UPPER UWCHLAN TOWNSHIP
BOARD OF SUPERVISORS WORKSHOP

August 13, 2024
4:00 p.m.

- I. Call to Order
 - A. Salute to the Flag
 - B. Moment of Silence
 - C. Inquire if any Attendee plans to audio or video record the Workshop
 - D. An Executive Session was held July 15, 2024 regarding a legal matter for a Conditional Use Decision and regarding personnel – Boards/Commissions candidates.
- II. Park & Recreation Board ~ Junior Member Appointment
- III. Village Concept Plan ~ Updated

DELIVERY TRUCK LEAVING SITE TURNING LEFT

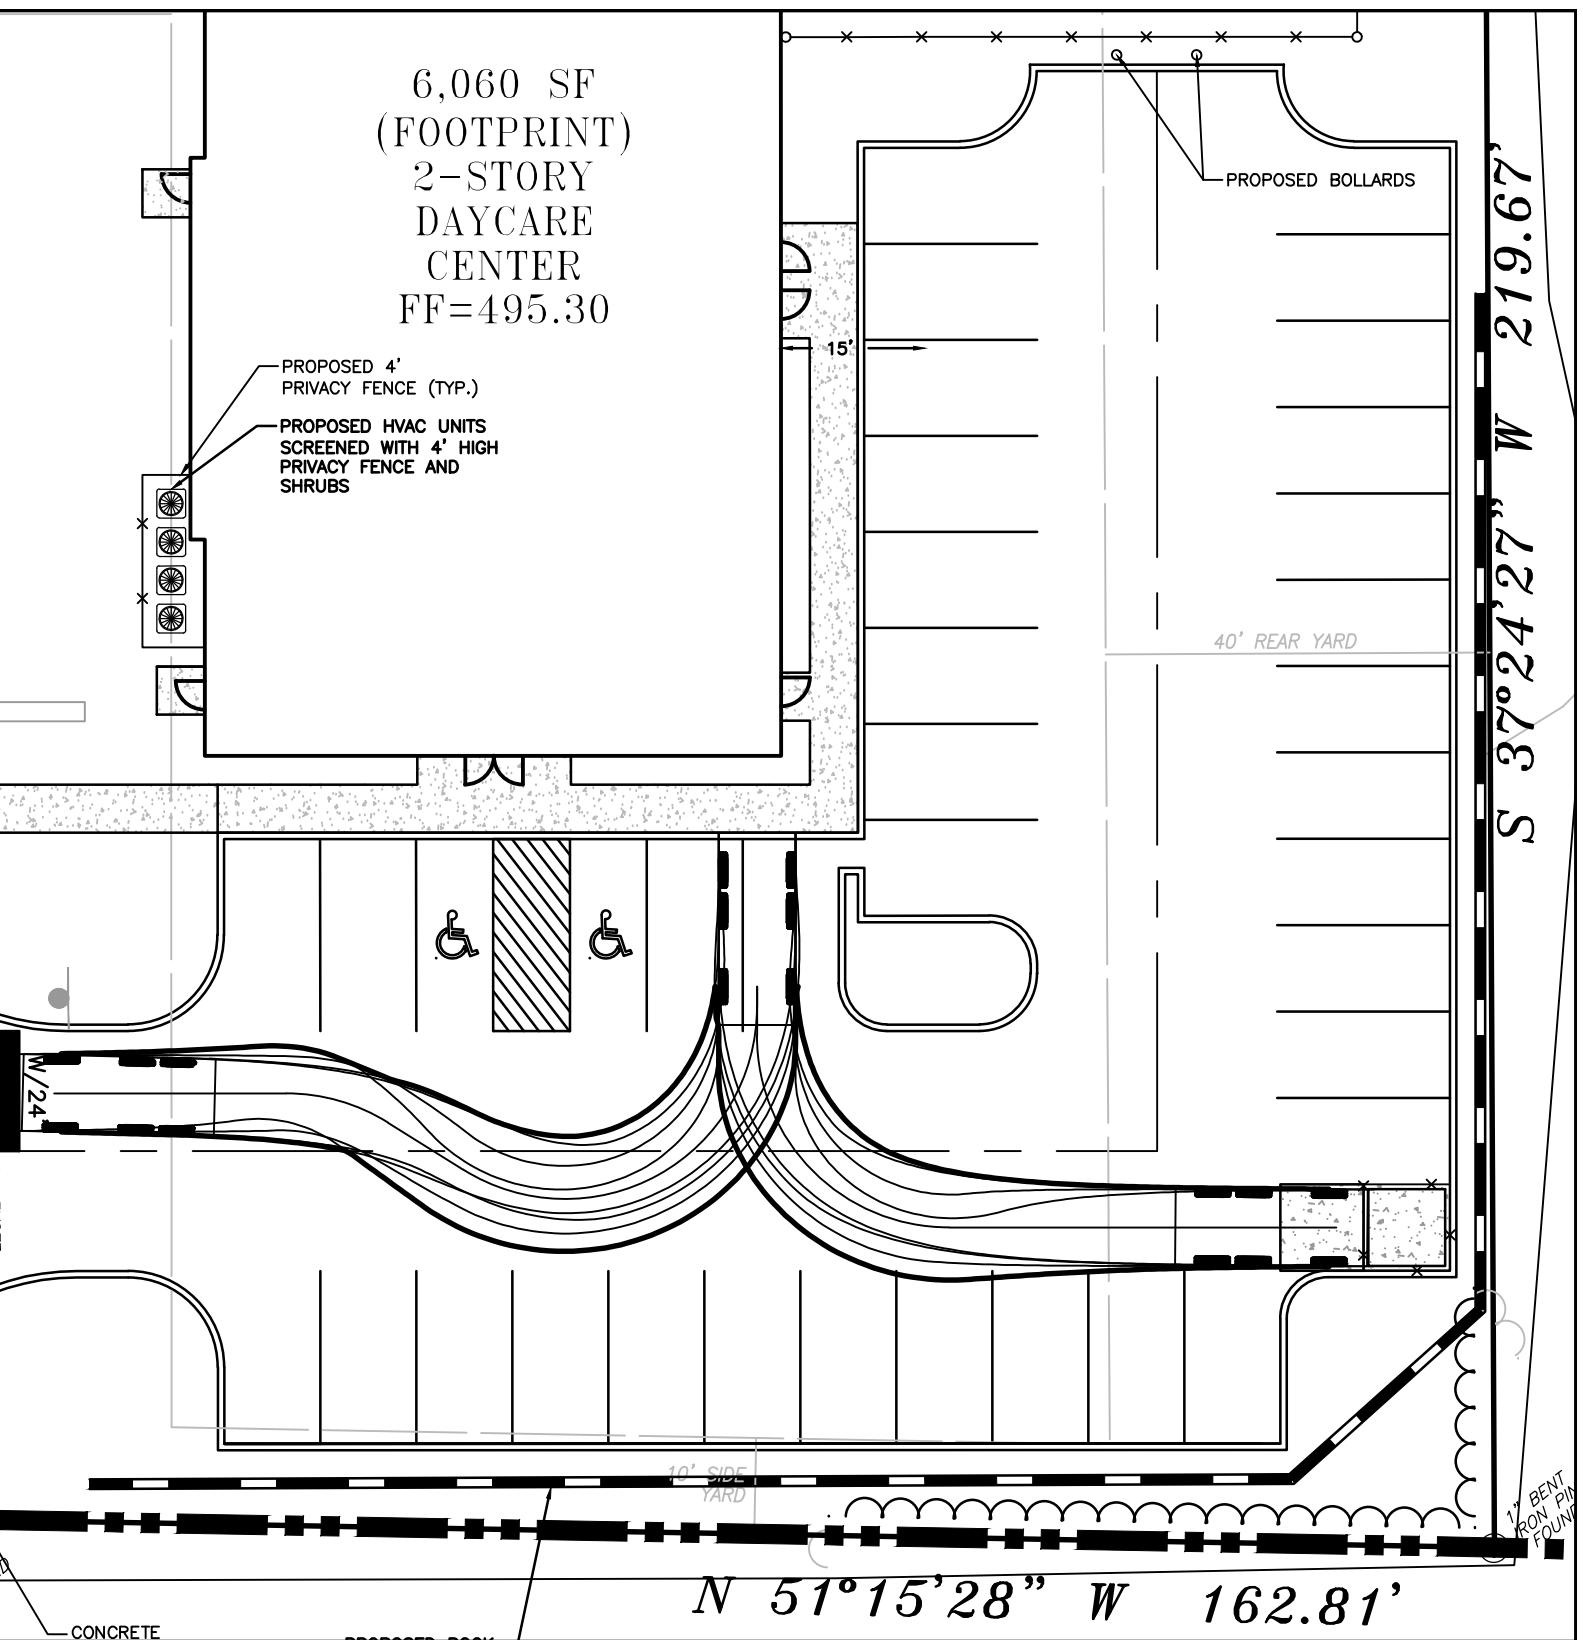
- 5. The sight line for left-turn entering vehicles looking ahead has been revised and is now measured from a point in the south bound lane, 35-feet east of the centerline of the proposed driveway to a point in the center of the north bound lane, 324 feet west of the centerline of the proposed driveway. (See Sheet 15 of 16)
